**16497 S Kennedy Rd. – Reply by owner to the appealing parties questions**

NICOL RESIDENCE

16497 S KENNEDY RD

1ST FLOOR PLAN

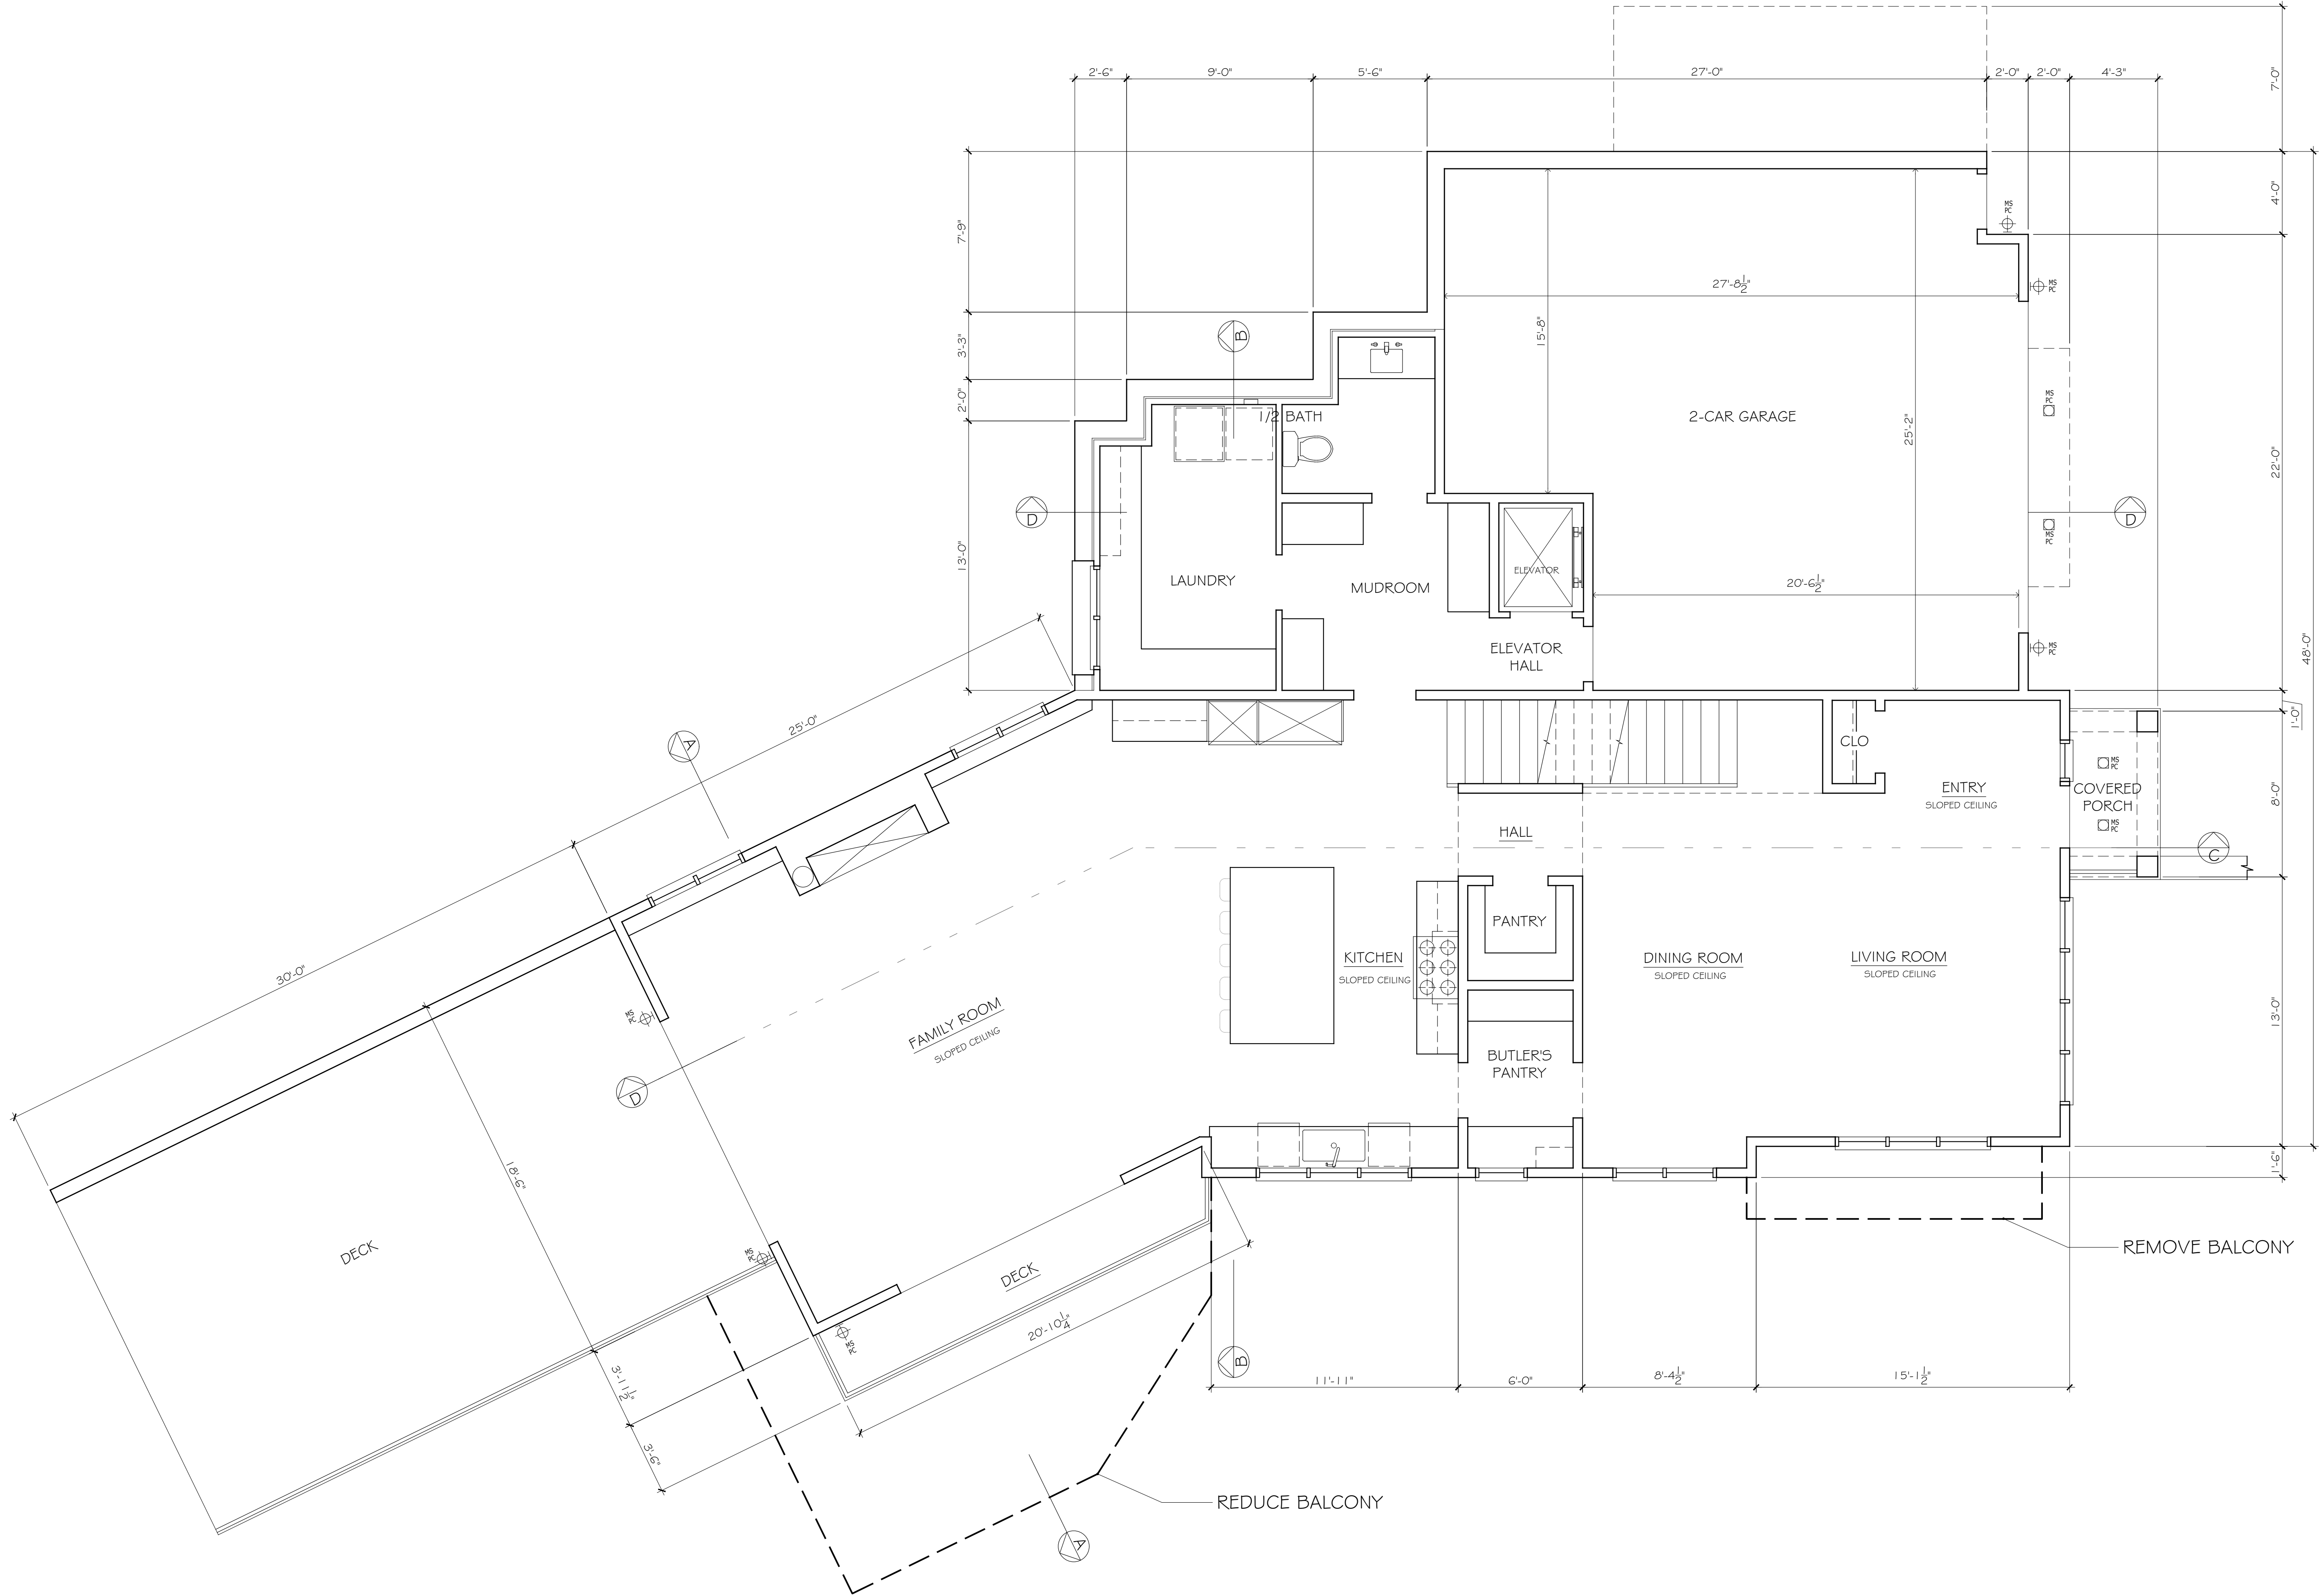
13. Photos provided by the appealing party: The photos below show that the appealing parties oak trees block 99% of the orange netting of the story poles.

SOUTHWEST ELEVATION

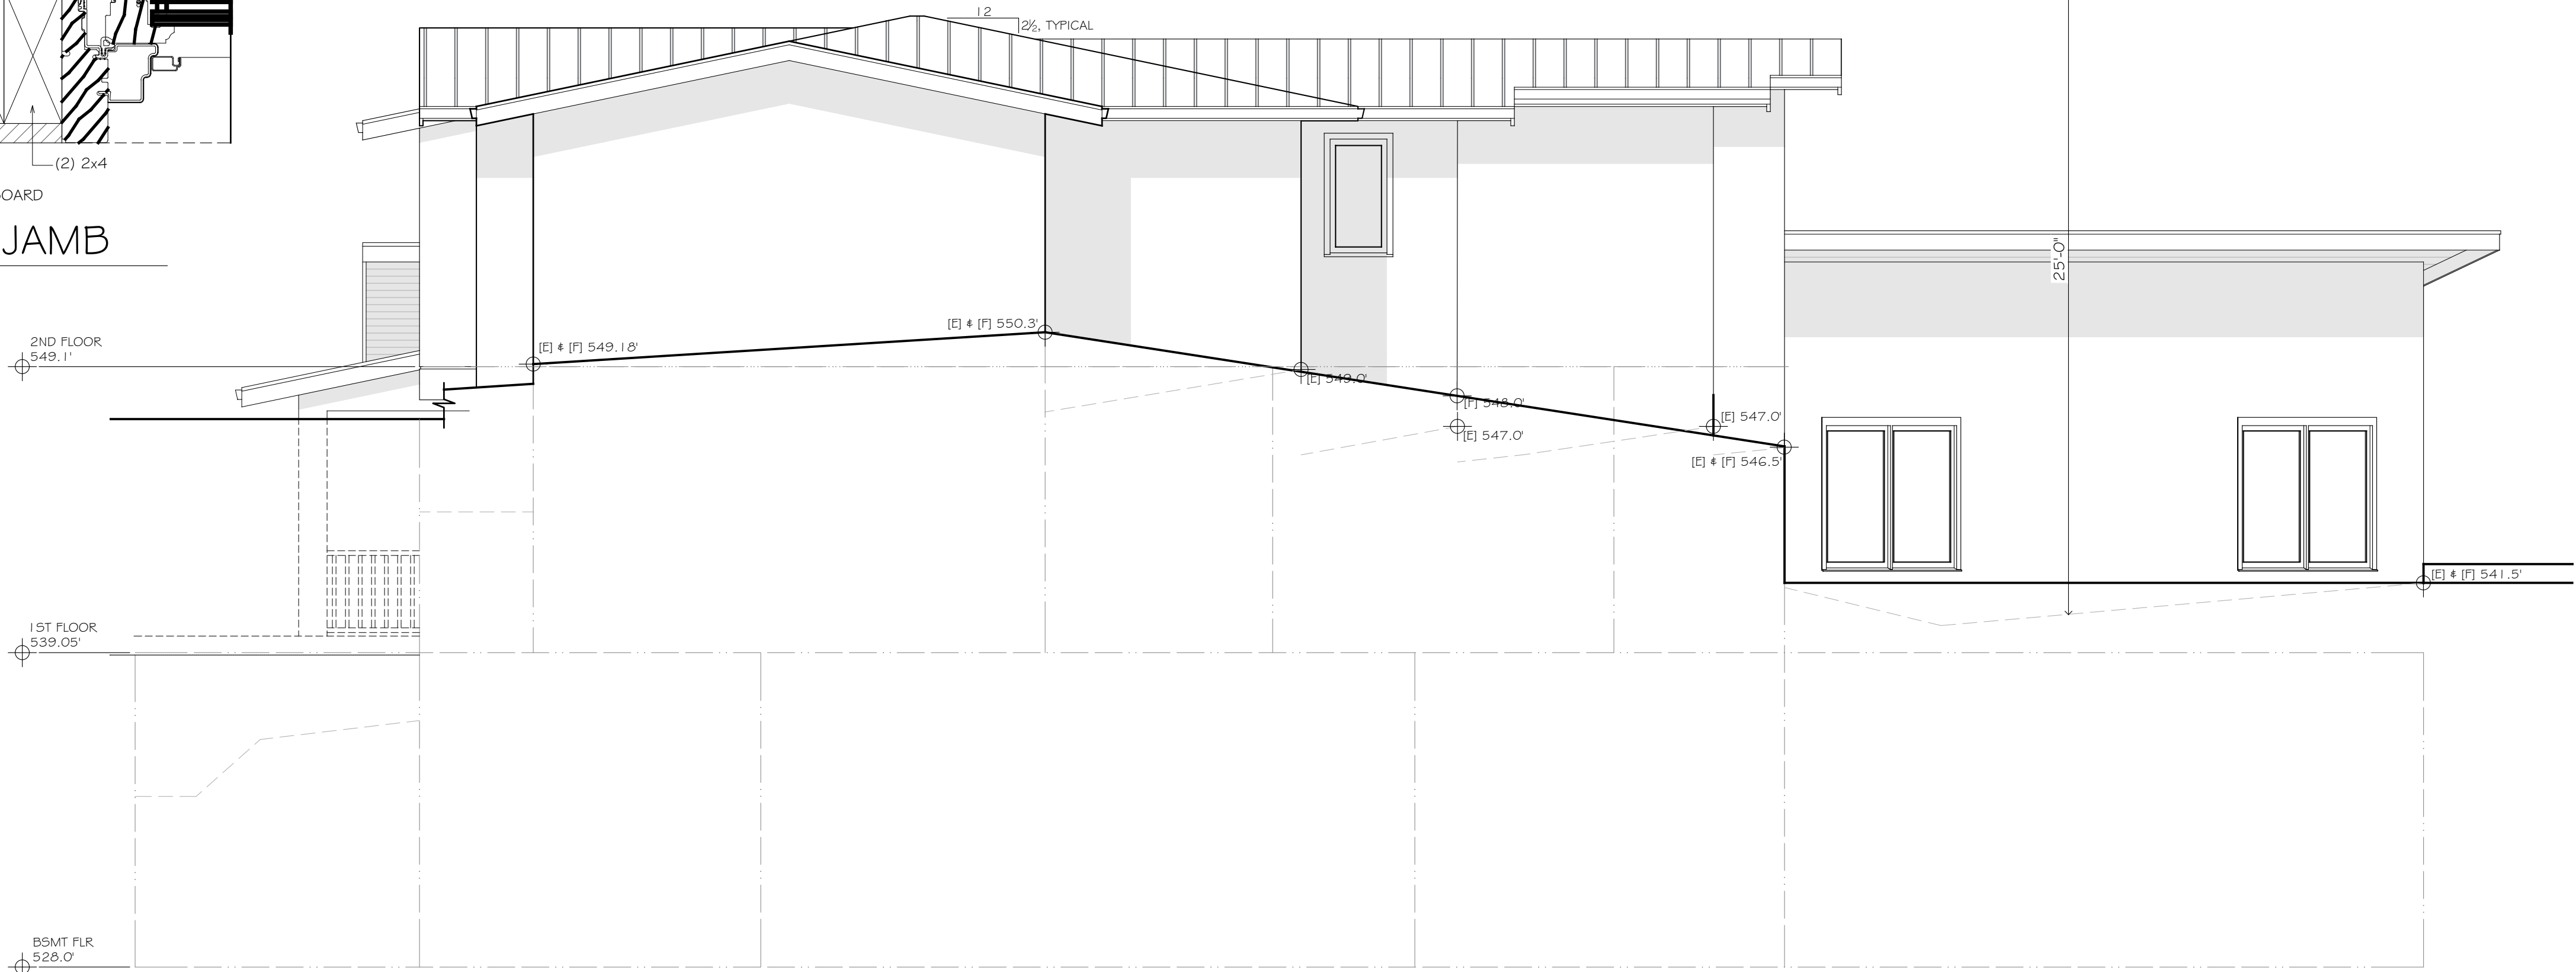
PREVIOUS GLAZING = 627.75 SQ.FT.  
PROPOSED REDUCED GLAZING = 498.25 SQ.FT.  
(OR CHANGED TO OBSCURE GLASS)  
= 21.4% REDUCTION
